Dear Editor,

Thank you very much for arranging the review of our manuscript. We also want to express our sincere gratitude to the reviewers for reviewing our manuscript. They were very helpful in pointing out the weak and unclear parts of the manuscript. Based on the reviews, we have made several modifications of the original manuscript and thereby improved it significantly. The biggest change is the addition of an appendix with tables presenting some important characteristics of the wind turbine inflow.

Reviewer 1

Figure 1: Plot of 10 minute averaged power as a function 10 minute averaged free-stream velocity. From left to right: a) $z_0 = 2 \cdot 10^{-4}m$, b) $z_0 = 1 \cdot 10^{-1}m$ and c) $z_0 = 5 \cdot 10^{-1}m$

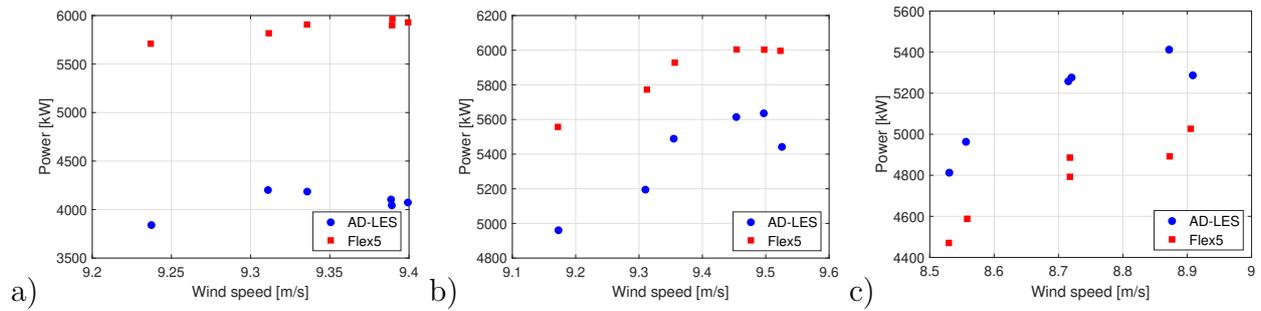
P3.72: With only 6x10-min samples, have you reached converged statistics to make an unbiased assessment of the differences between flat and complex terrain? Please justify if 1.5 hr simulation time is long enough.

P3L59: "From the simulation we compute ensemble averaged 10 minute statistics and evaluate the variability via the standard error of the mean". What is meant by "ensemble" here? 10 minute time-averaged values? Ensemble over different roughness lengths? It seems not, according to Figure 1. Also, I do not see any indications of variability in the Figure 1. Is the error-bars too small to be seen?

The variability in the power estimates is small so we are confident that our simulations are long enough to get an unbiased assessment. We agree with you that 6 samples of 10 minutes may not be enough to establish the fully converged statistical difference between AD-LES and Flex-standalone. However, our aim here is only to show that there can be a significant terrain induced difference between the two types of predictions and to give an impression of how big this difference can be.

It should be emphasized that the inflow used for the AD-LES and Flex-standalone is exactly the same for each 1.5hr case and thereby we overcome many of the potential issue related to lack of statistical convergence. When comparing the individual 10 minute predictions we of course find some variability but still the offset between AD-LES and Flex-standalone is very consistent. This is illustrated in the plots below, which shows the 6x10-min samples for three selected cases at different roughness levels. In order to show that our analysis is not affected by lack of statistical convergence, we have now added error bars in the power curve plots. In addition we have added the following wording in the caption to Fig. 1:

Note that the error bars indicating the standard error of the mean are included but they are barely visible.

The error bars are now included in Fig. 1 but they are barely visible.

Figure 2: Contours of the mean streamwise induced velocity for different surface roughness levels. The induced velocities are scaled with the free-stream velocity at the hub position of the wind turbine.

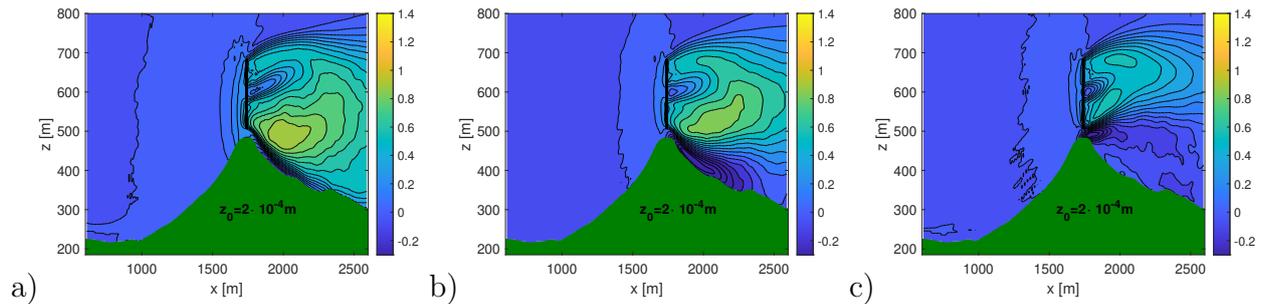
P4.Fig2: The velocities are scaled with the free-stream velocity at the position of the wind

turbine i at hub-height right? I would add a third row with the difference between the two contour plots, without and with turbine, to highlight and quantify differences more clearly.

P4L81: "At $z_0 = 0.5$ m there is a large separated region behind the ridge, which acts as a barrier and therefore pushes the flow passing over the hill upwards. As a consequence the free-stream velocity initially accelerates downstream of the rotor and as shown in Fig. 2f) this causes a weaker wake leading to lower induction in the rotor plane". I suggest rewriting these sentences. I think I agree with the authors, but the phrasing is confusing. My problem is with the fact that "flow separation" traditionally means separation from the surface, clearly seen in (b), (c) and (f). But can we really talk about flow separation if the flow is following the surface in (d) and (e)? I would suggest calling the low wind speed region in (d) and (e) "wake region". I am not sure if the wake region is smaller in (d) than in (f). I am also wondering if the existence of flow along the associated with under the curve performance.

I would suggest adding hub-height and turbine extent to the Figure 2.

Yes, the contours are scaled with the velocity at the hub position of the rotor. We have clarified this by changing the last part of the caption in Fig. 2 from:

The velocities are scaled with the free-stream velocity at the position of the wind turbine.
to

The velocities are scaled with the free-stream velocity at the hub position of the wind turbine.
Thanks for the advice of adding an additional row of plots. These plots are shown in the figure below. As seen these plots essentially show the same flow behaviour as Fig. 2 d-f and therefore

are not adding much more value to understanding the flow mechanisms at play. Therefore, we have decided not to do include them in the article.

What we write is that there is a large separated region behind the ridge when $z_0 = 0.5$ m and that this separation bubble shrinks when the roughness decrease. You are right that at the lowest roughness the free flow is nearly attached so here there is no apparent flow separation. To clarify this we have rephrased the sentence about the shrinking separation region to:

As the roughness is decreased the separated region behind the ridge becomes smaller and smaller and eventually the flow becomes nearly attached to the terrain surface.

The wind turbine wake is smaller in f) than in d) because of the accelerating background flow just behind the turbine in the former case.

The turbine position is indicated as dashed/full lines in Fig. 2. The hub height and diameter is now also specified. See our answer to the first comment from reviewer 1.
